ENVIRONMENTAL COMMITTEE MEETING

January 7, 2026

Subject: Review of redevelopment plans for 424 Butler Ave. E.

PROJECT
BUTLER AVE DEVELOPMENT

DRAWING Nº
C-1

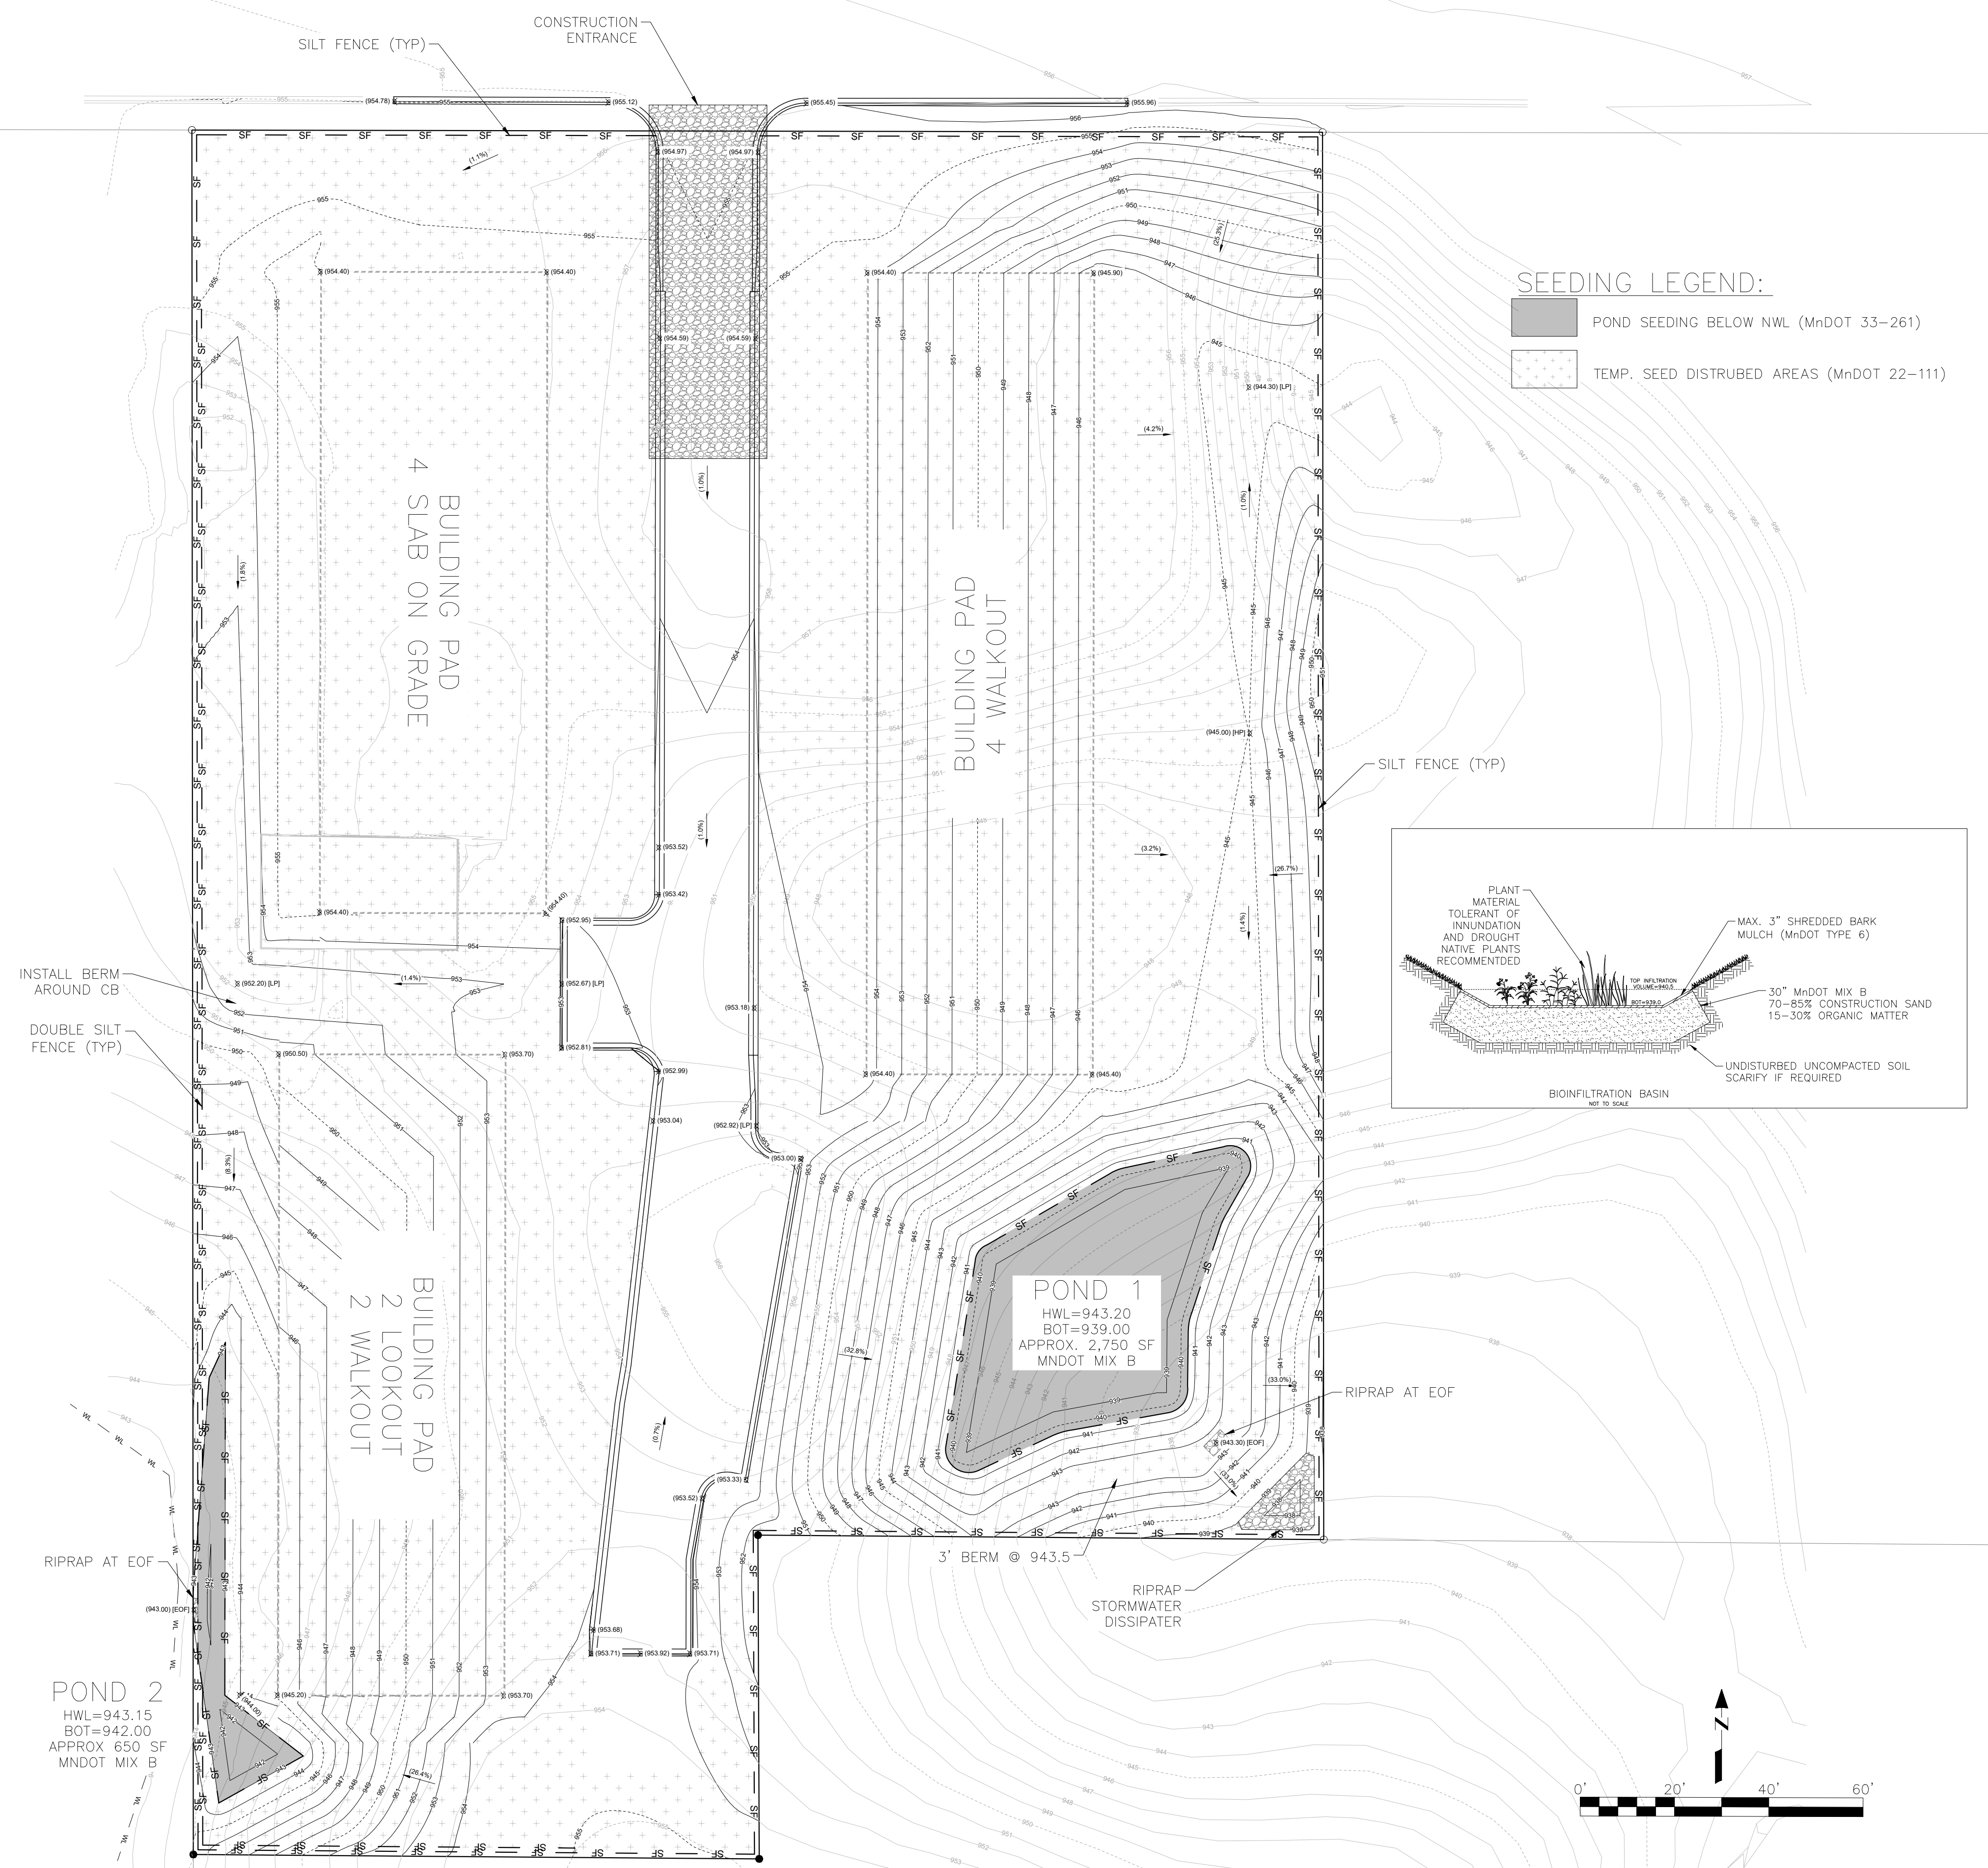
The submitted plans detail the removal of all trees on site, as the site will need to be re-graded to ensure sufficient drainage. Page C-1 of the submitted plans shows further details on the type and status of the existing trees, but a summary of the removals is included below.

When trees are removed as a part of the site plan process, at least 30% of the quality trees (at least 2.5 cal. in.) must be replaced. Based on the submitted plans, the minimum replacement requirement calculates to 359 inches (roughly 144 trees if measuring at 2.5”).

DRAWING Nº
C-3

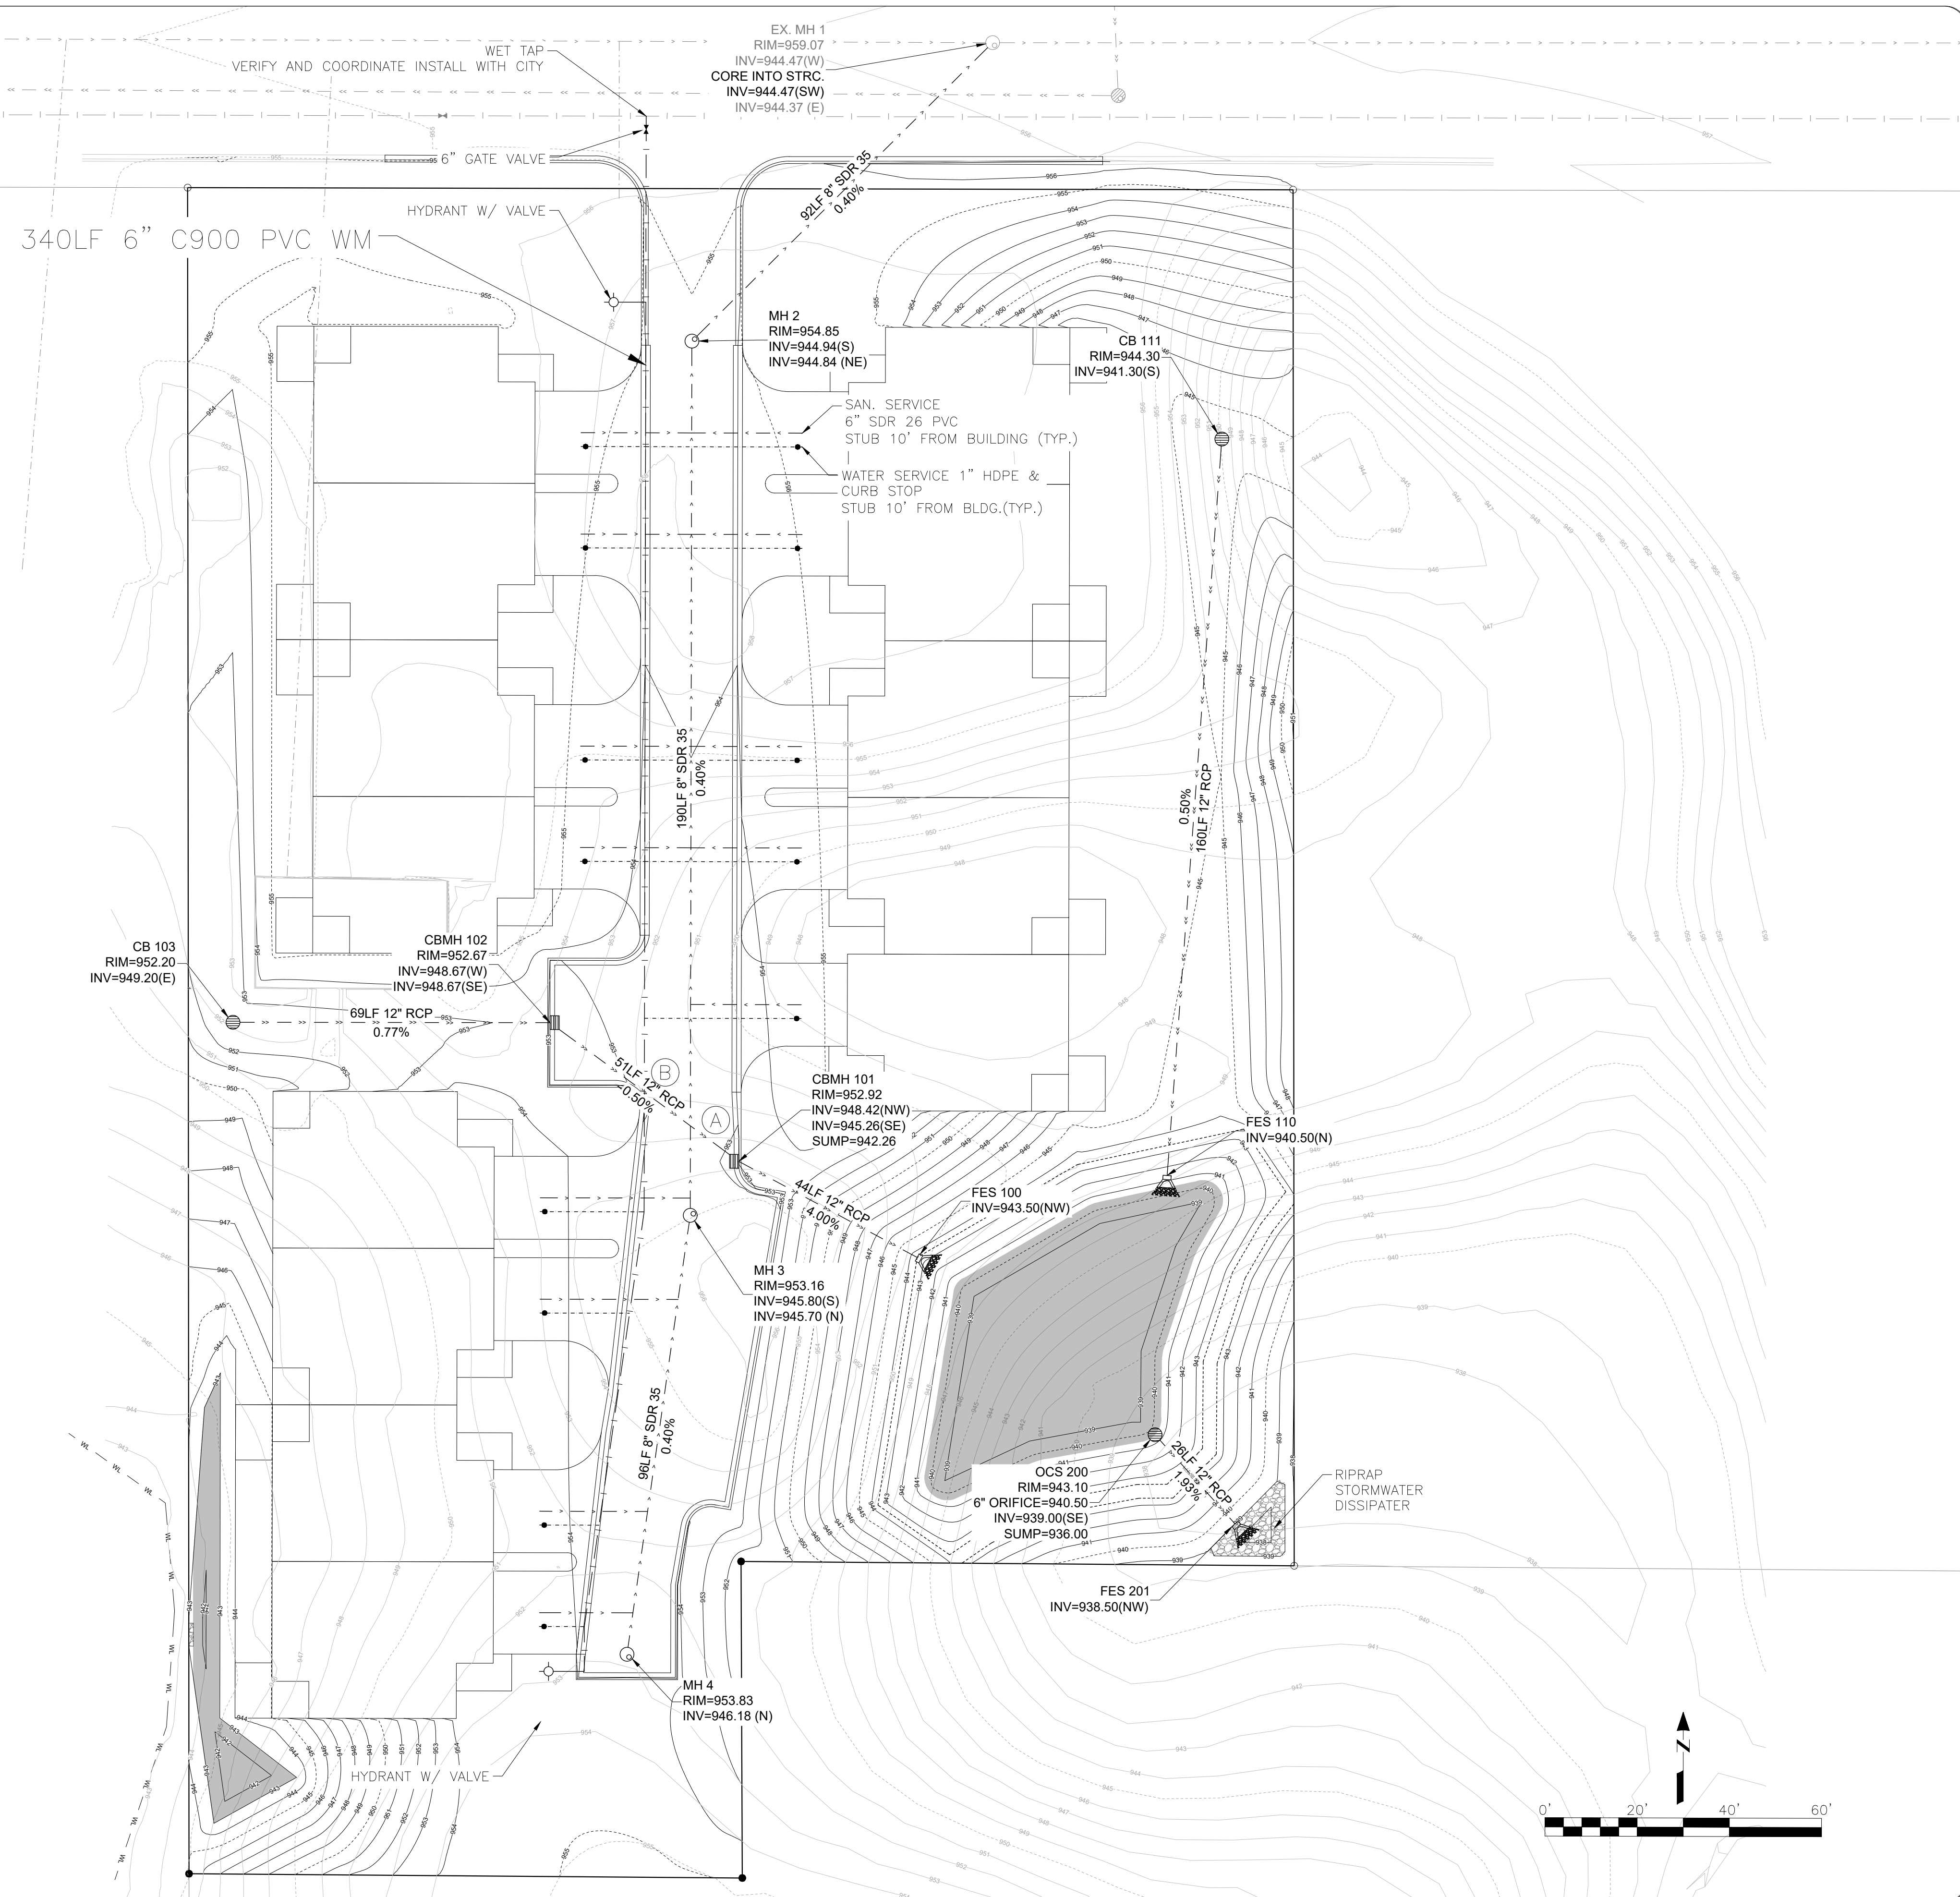
The majority of the stormwater from the site will be filtered through the biofiltration basin in the southeast section of the site, with a small portion also draining to the southwest. Final site grading can be seen on page C-3 of the included plans.
